Manufacturing Bulletin

Subject: Carrier Tape Pocket Design Change - Reel Shipment

Date: October 13, 2006

Affected Product List: AMB0480A5RJ, AMB0480A5RH

Photos

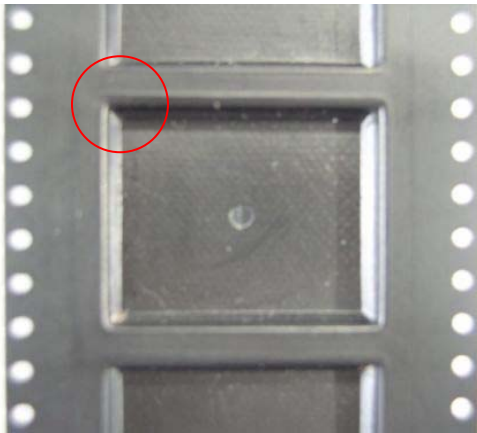
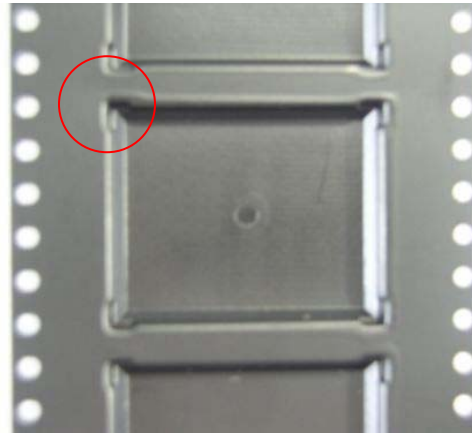
Integrated Device Technology, Inc has introduced a new carrier tape pocket design for AMB product shipped in reel form. Kindly refer to the attachment for the new design which is known as the “dog bone” design. The purpose of this change is to improve the device pick up process at the customer SMT machine. The “dog bone” design provides 4-corner relief to eliminate friction between device corners and the pocket corners during the pick and place at board mount process. This new design has been tested and meets ASTM D5276-98, Standard Test Method for Drop Test of Loaded Containers by Free Fall.
